ZONING BOARD OF APPEALS MEETING

LOCATION: TOWNSHIP ANNEX, 7527 HIGHLAND ROAD, WHITE LAKE, MICHIGAN 48383
THURSDAY, NOVEMBER 12, 2026 – 6:30 PM

Applicant: Brandon Steele

Request Summary: Front Yard Setback and Nonconforming Structure Variances

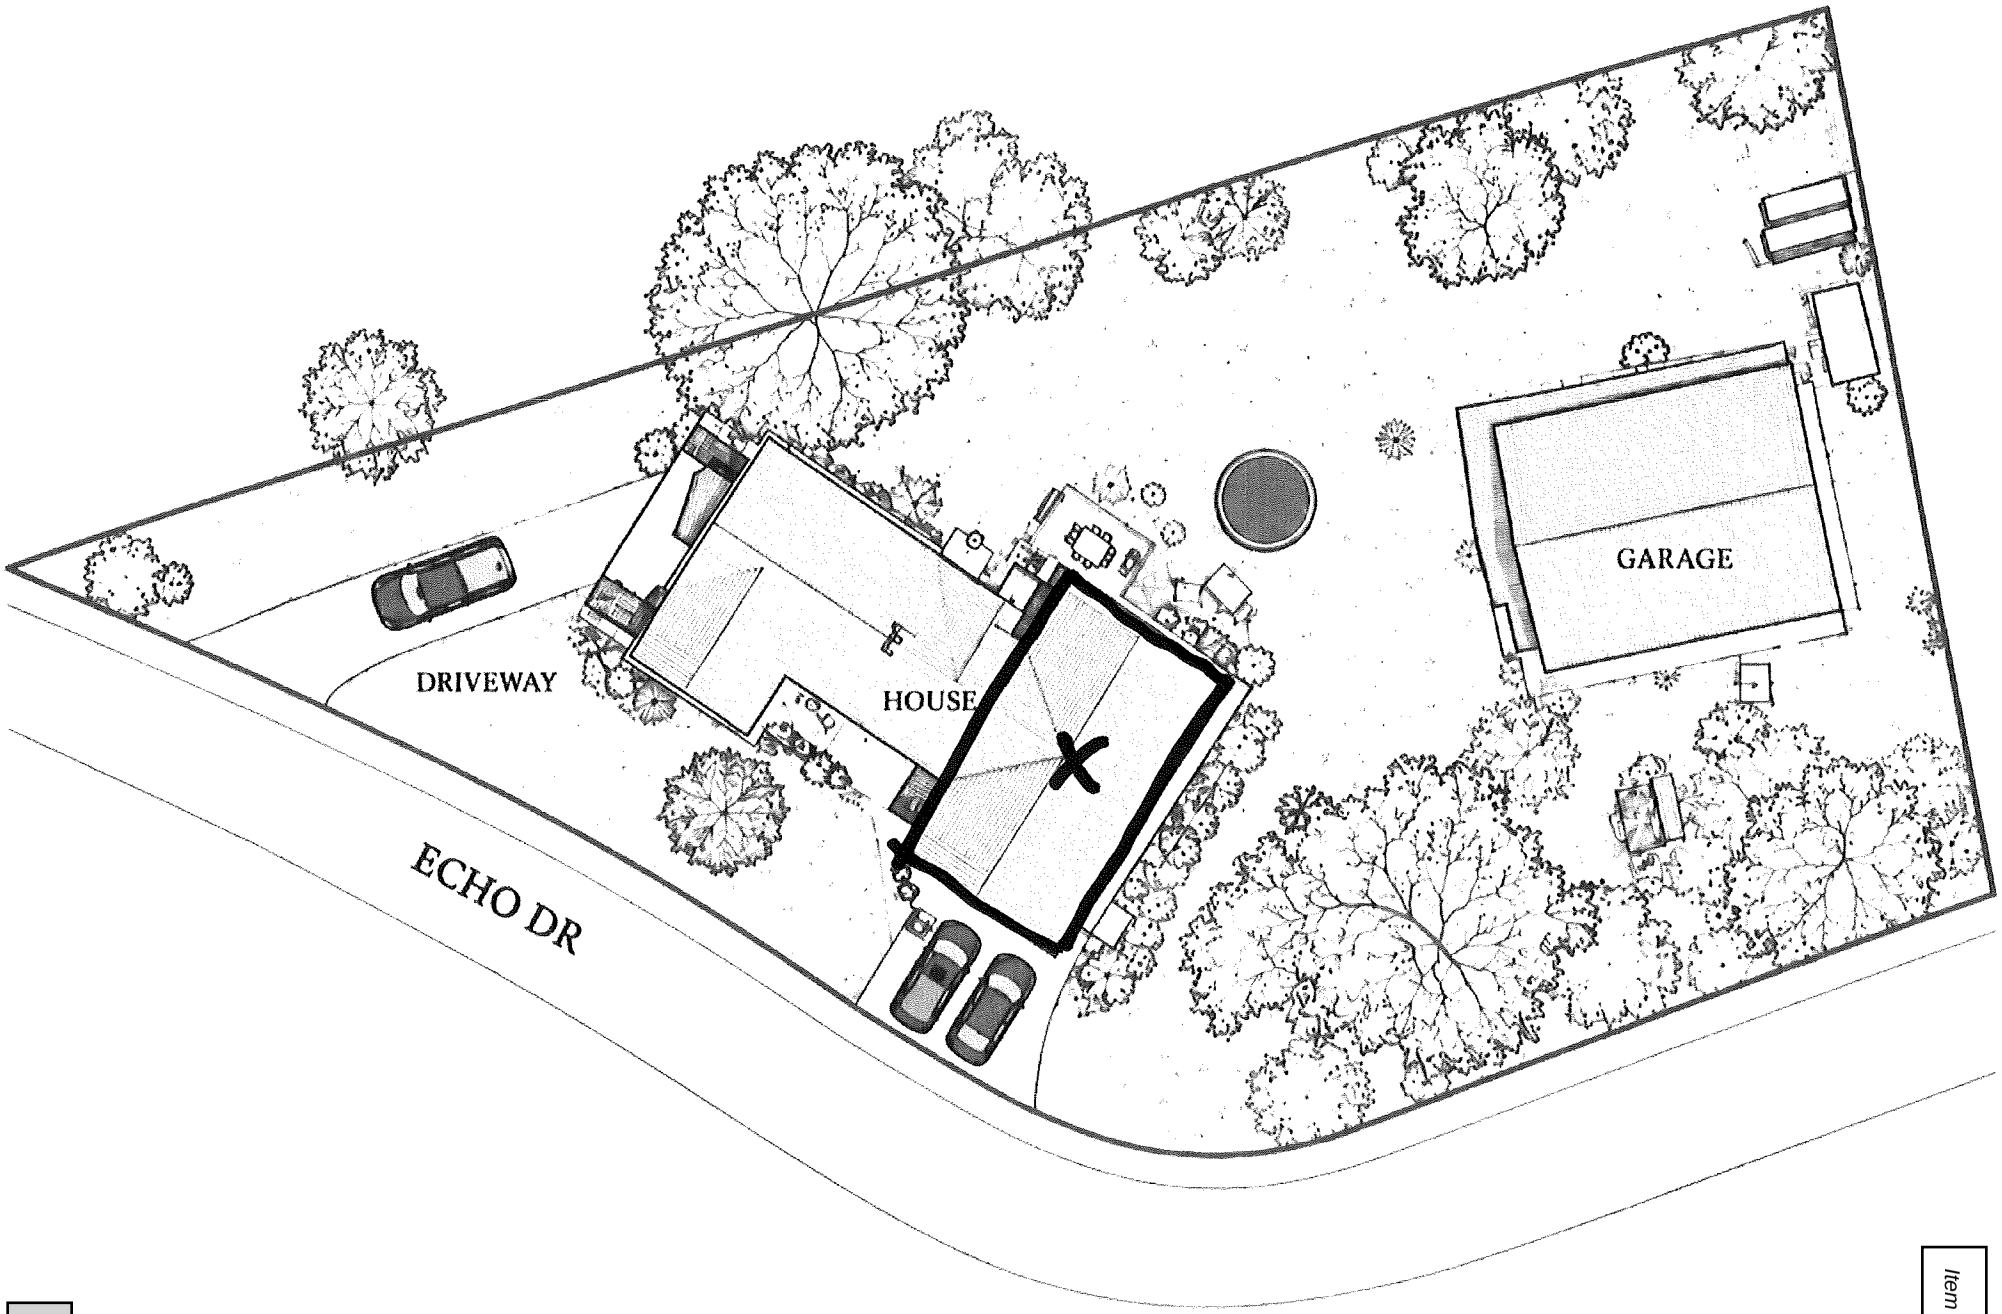
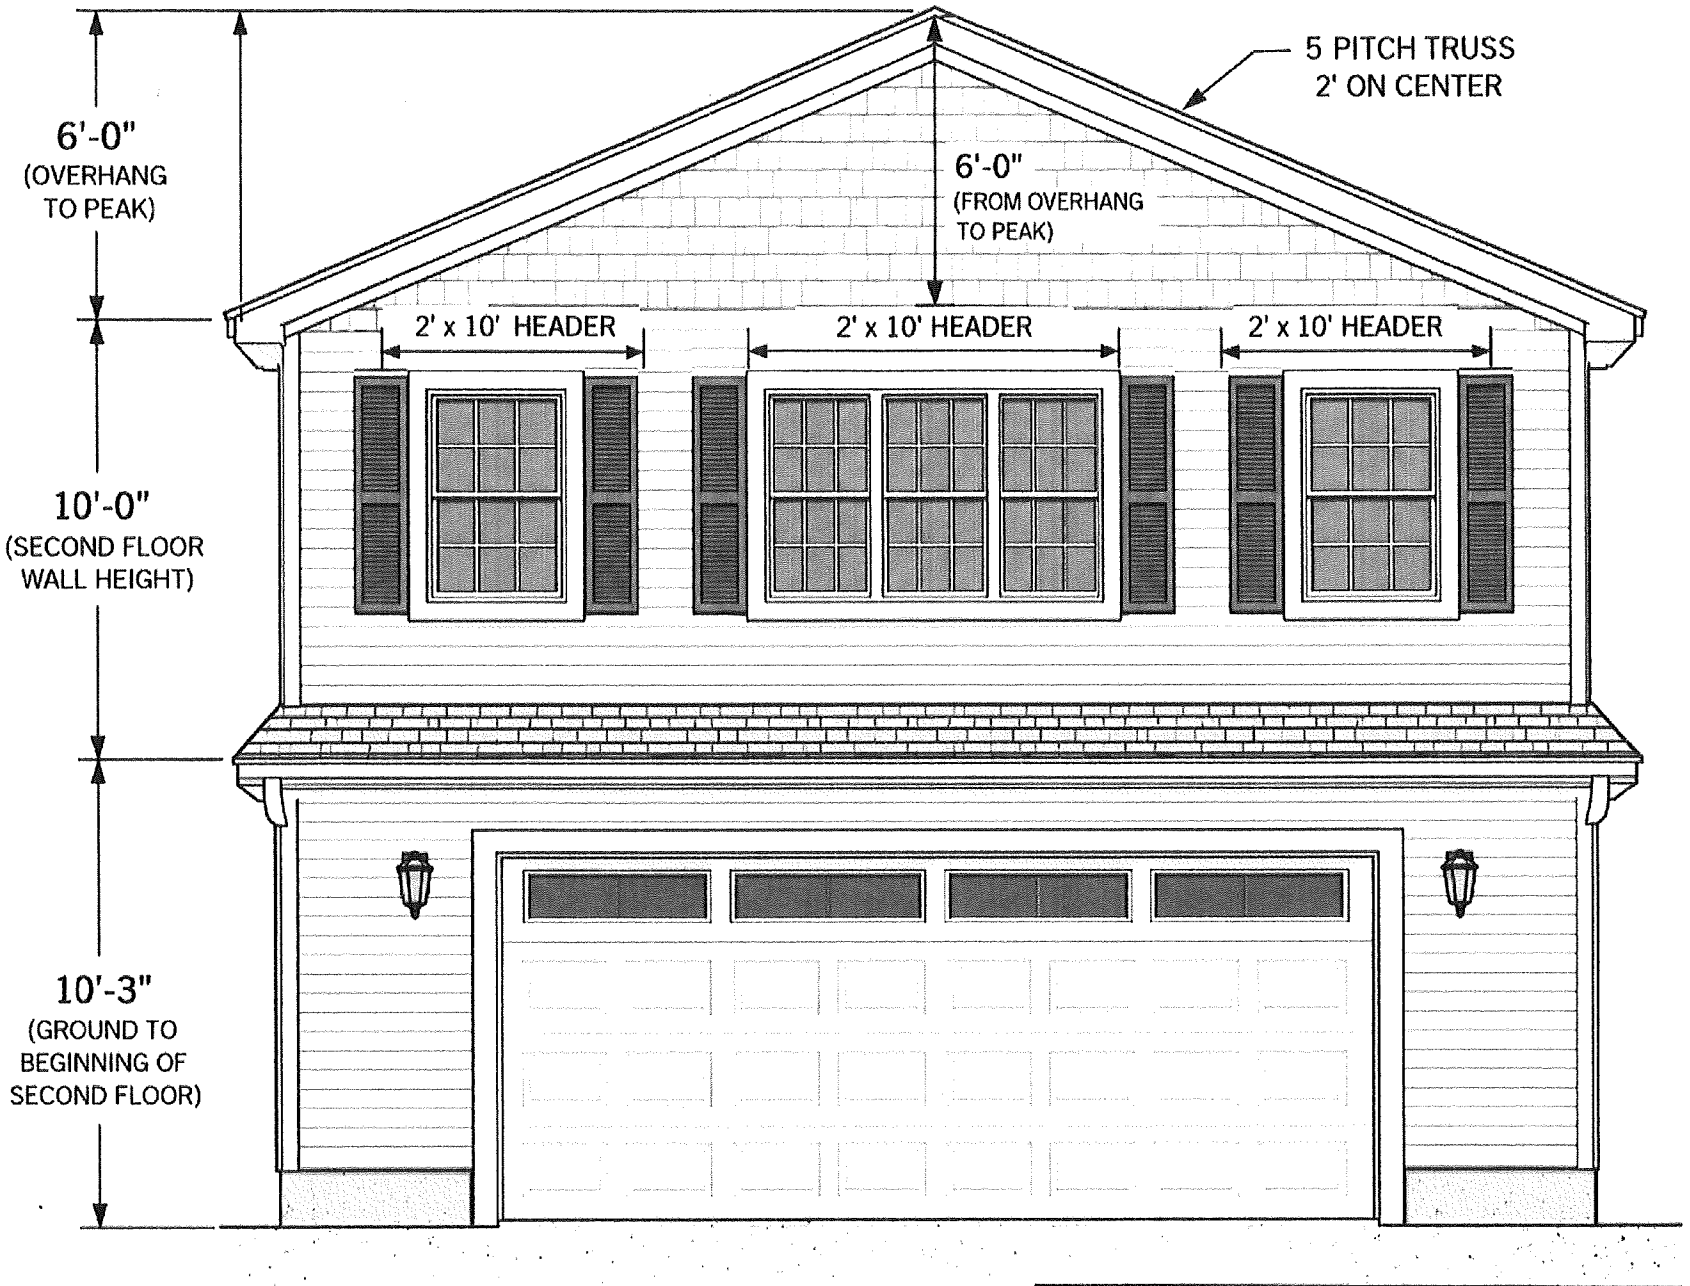
The existing structure is legal non-conforming. The residential structure does not meet the required front yard setback requirements. The proposed 2nd story addition increases the cubic content of the non-conforming structure over the existing garage which has an approximate 16 ft front yard setback measured from the road right of way

The applicant proposes constructing a second-story addition above an existing portion of the residence located approximately 16 feet from the road right-of-way, where a 30-foot front yard setback is required. Although the addition would not extend the existing building footprint or further reduce the horizontal setback, it would increase building volume within the required front yard.

The approximately 0.664-acre property also contains substantial open space behind the residence, including relatively level areas that may accommodate a ground-level addition. The applicant identifies the private well, located approximately 18 feet behind the home, as a constraint, along with the existing fireplace and interior layout. The extent to which these conditions limit reasonable alternatives has not been fully established.

Constructing the addition vertically would preserve the existing building footprint, avoid additional impervious surface coverage, and minimize disturbance to established site improvements. Conversely, the proposed construction would introduce additional building mass within the required front yard setback, which is intended to maintain separation between structures and the roadway.
